Reference: **Draper Prison**

> **Vocational Training Center** DFCM Project No. 04256100

Subject: Addendum No. 1

Draper Prison Vocational Training Center

C201

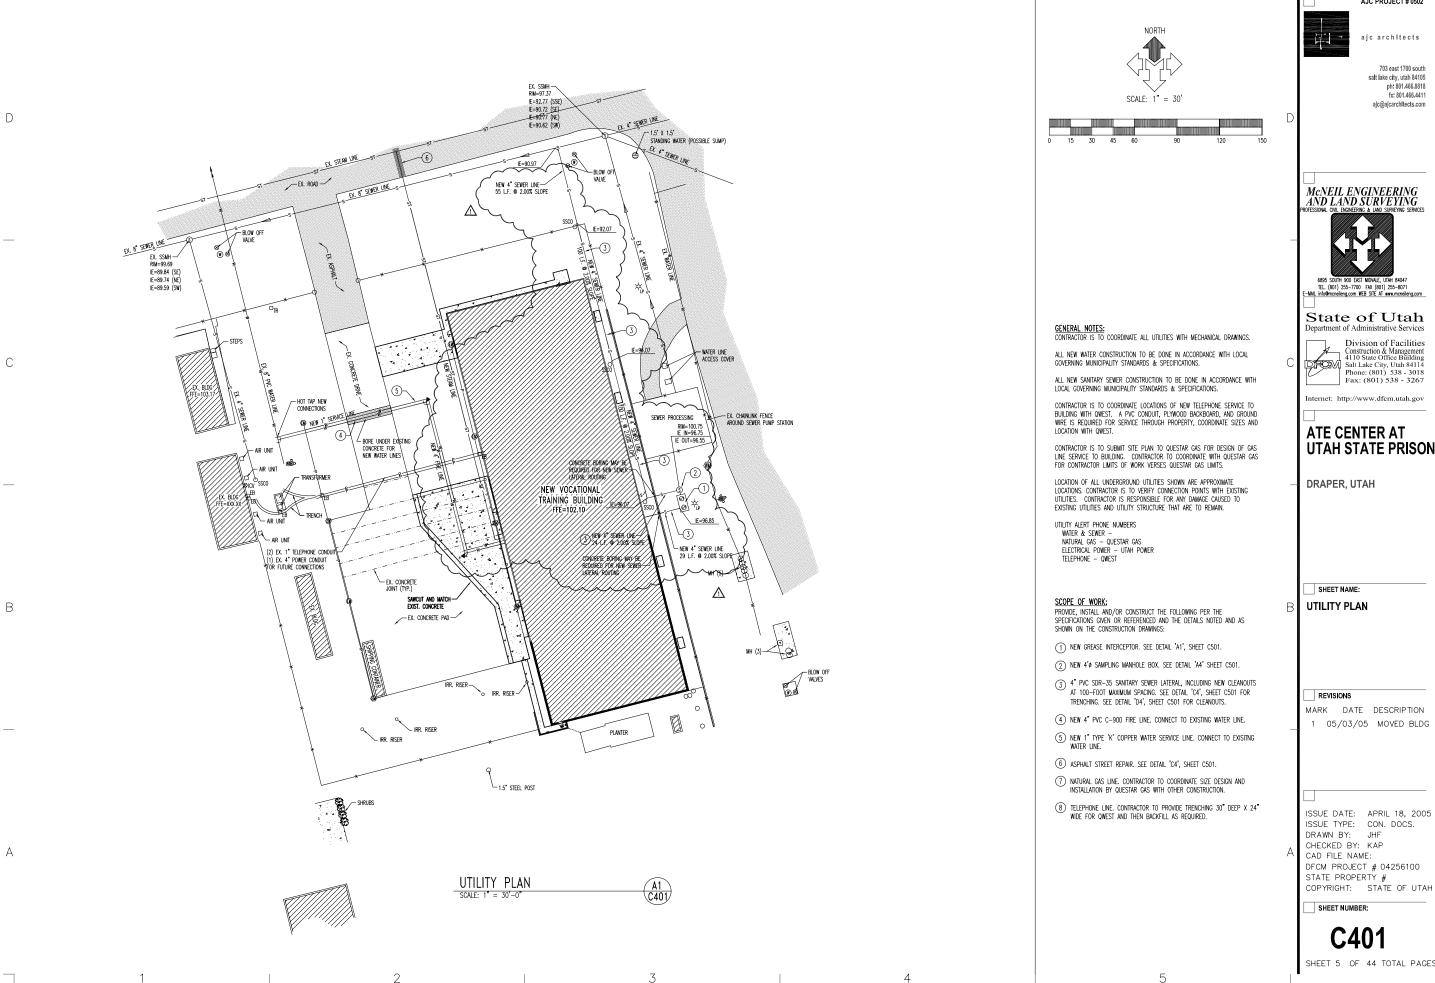
- Item 1: Building to be located approximately 16'-10" south of current project location to provide for more room for the paint booth at the north end of the building. See attached revised sheets C101,C201,C401, AS101 and AS102.
- Item 2: Approximately 120'-4 1/2" lineal feet of fencing is to be removed. Approximate height of fence is 4"-0" from grade See attached revised sheet AS101.
- Item 3: Paint booth to be located outside of building, rotated and fully sprinklered.

MARK DATE DESCRIPTION 1 05/03/05 MOVED BLDG

WALL ASSEMBLY AD1.1

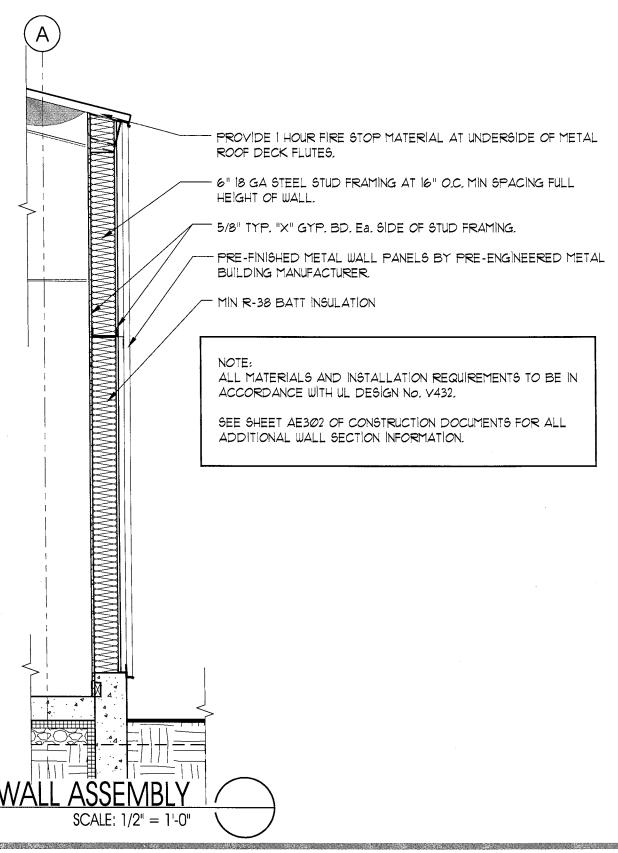
- Item 6: Clarification erroneous key notes removed from sheet AE102 between grids 4 and 5 and A.2. See attached revised sheet AE102.
- Item 7: Exterior wall at grid line A to be rated one (1) hour. See attached supplemental drawing AD1.1 and AD1.2 for assembly and UL listing. See attached revised sheet AE601 for revised door schedule and attached revised overhead coiling door specification section 08331 included herein in its entirety. See electrical addenda for fire alarm interlock.

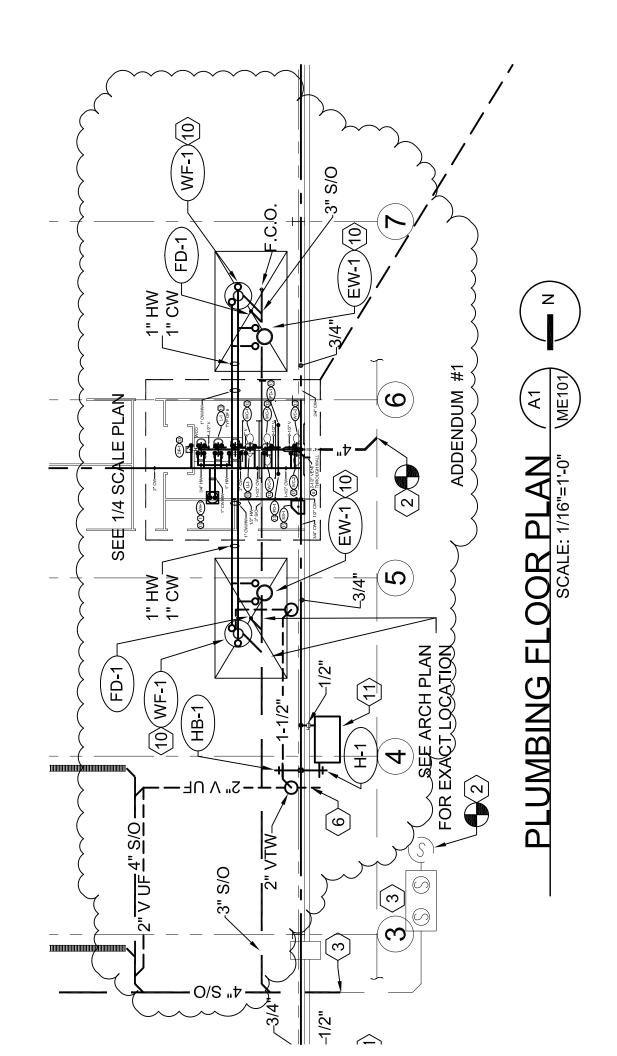
- Item VI-1. Sheet PE101 Add wash fountain and eyewash in woodshop area. Route waste line from both wash fountains and floor drains to sand and oil separator line. See attached revised sheet PE101(and 8-1/2 x 11 updated plan).
- Item VI-2. Sheet PE601 Electric water heater shall be a 40 gallon 4.5 KW heater. See revised sheet PE601 (and 8-1/2 x 11 updated plan).

AUTO SHOP EP101a

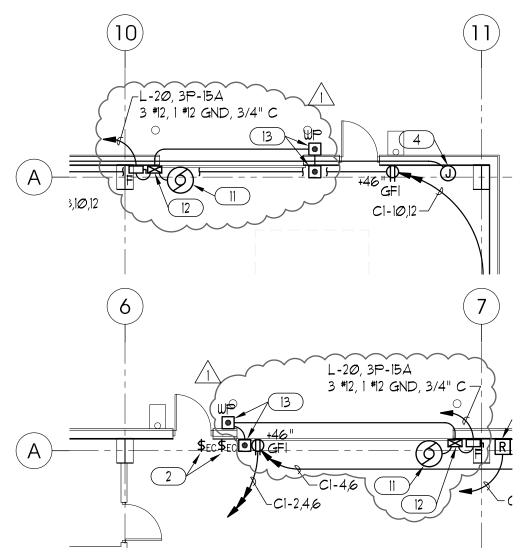
- 1. Add Electrical Service for Overhead Door Motors:
 - A. Provide electrical service to 3 exterior overhead door motors as shown on attached drawings EP101a, and EP102a.

PARTIAL REVISED POWER PLAN -WOOD SHOP EP102b

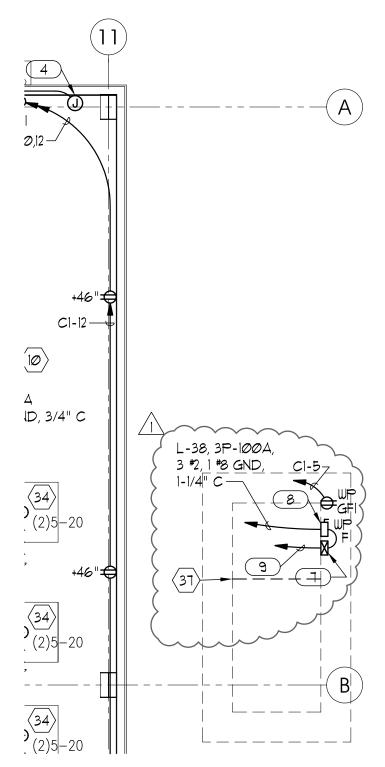
- 1) Coordinate door interlock requirements with door supplier.
- 3. Change Location of Paint Booth Electrical Connections:
 - A. Change location of safety switches, starter/control panels, and electrical connections for Paint Booth Exhaust Fan '26a', Paint Booth Heaters '26b', and Paint Booth lighting and control circuits to locations shown on attached drawing EP102b.
